Access Compliance Report

Public Rights-of-Way (Curb Ramps)

Intersection ID: 13895	Main Street: ELIZABETH_AV	Cross Street: TRAVIS_AV	Location: SE
ADA ID: 347B9119A942	Ramp Type: Perp	Initial Pass/Fail: Fail	Overall Compliance: No
Severity Score: 21.25			
Codes/Mitigation Info/Possible Solution		Field Measurements/Component Compliance

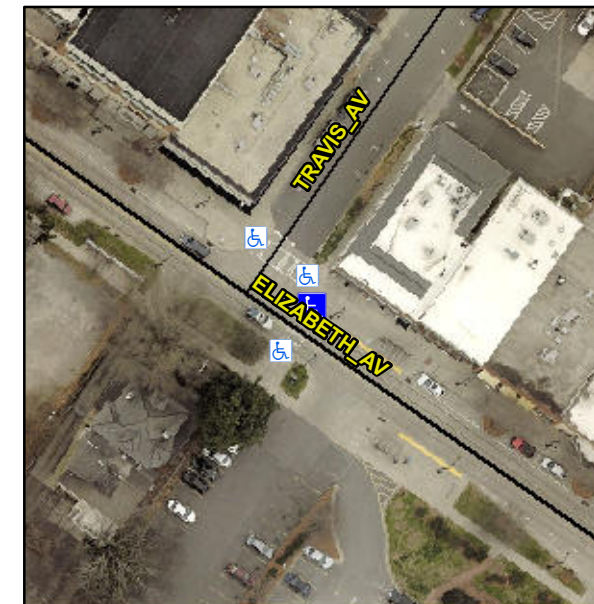
Not Found, R304.5.1, R304.2.2

Compliance	Description	Data	Compliance	Description	Data
N/A	Ramp Length (in)	72.0	No	Ramp Slope (%)	8.4
No	Ramp Width (in)	47.5	Yes	Ramp XSlope (%)	0.2
N/A	Flare Type LT	N/A	N/A	Flare Type RT	N/A
N/A	Flare Slope LT (%)	N/A	N/A	Flare Slope RT (%)	N/A
N/A	Flare Traversable LT?	N/A	N/A	Flare Traversable RT?	N/A
N/A	Landing Length (in)	N/A	N/A	DWS Provided?	N/A
N/A	Landing Width (in)	N/A	N/A	DWS Contrast?	N/A
N/A	Landing Slope (%)	N/A	N/A	DWS Length (in)	N/A
N/A	Landing X Slope (%)	N/A	N/A	DWS Full Width?	N/A
N/A	Landing Curb? (Y/N)	N/A	N/A	DWS Offset (in)	N/A
N/A	Shared Landing?	N/A			
N/A	Gutter Ponding?	N/A	N/A	Gutter Slope (%)	N/A
N/A	Gutter Lip Ht (in)	N/A	N/A	Gutter X Slope (%)	N/A
N/A	Painted X Walk1?	Yes	N/A	Painted X Walk2?	N/A
	X Walk 1 Direction	To SW		X Walk 2 Direction	N/A
N/A	X Walk 1 Width (in)	112.0	N/A	X Walk 2 Width (in)	N/A
	X Walk 1 Slope (%)	3.4		X Walk 2 Slope (%)	N/A
	X Walk 1 X Slope (%)	1.5		X Walk 2 X Slope (%)	N/A

N/A	Ramp inside XWalk1?	Yes	N/A	Ramp inside XWalk2?	N/A
	Road Slope (%)	N/A	N/A	Clear Space?	N/A
	Road X Slope (%)	N/A	N/A	Clear Space to XWalk (in)	N/A
N/A	Any Obstructions?	N/A	N/A	Storm Grate/Utility Hazard?	N/A
	Obstruction Type			Storm Grate/Utility Type	
		N/A			N/A
		Yes		Surface Condition? (G/P)	Good

Remove & Replace Entire Ramp.
